DESIGN AND ACCESS STATEMENT: ADDENDUM 2

DECEMBER 2024

Garrick Cottage,
Church Street, Hampton
TW12 2EG
Planning Application 24/2270/HOT

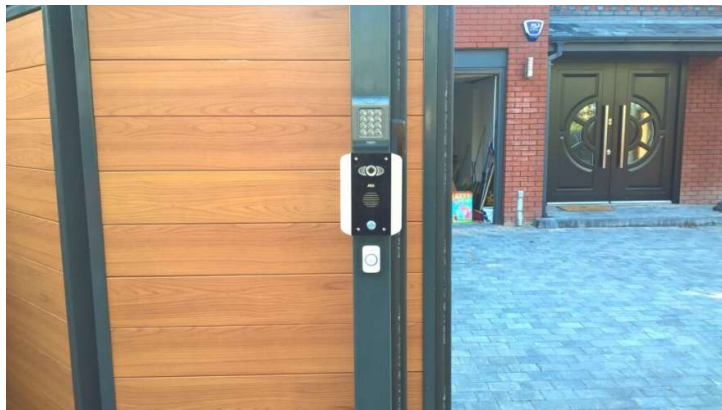
Heritage and Urban Design: a request from the Conservation and Urban Design Officer to clarify that (A) the height of the new boundary entrance flank walls will match (and not exceed) the existing wall, and that of the adjoining Garrick Lodge wall, as well as (B) how the junction would be addressed between the two. (C) Concerns about the appearance the gate when closed, with wheels possibly being visible, and further information on the design of the gates beyond the description of them being 'metal and timber'.

The revised Elevation drawing PL05 Rev B makes it clear that the new extended yellow stock brick wall will not be taller than the red brick wall that it is to replace. The drawings also clarifies how the junction is to be addressed between the two at the boundary with Garrick Lodge. The elevation drawing showing the new gate has the support wheels completely invisible, running in an inset channel. There is also an expanded description of its proposed appearance.

These images have horizontal infill timbers, whereas the proposal will have them set vertically. They can equally well be painted or stained.
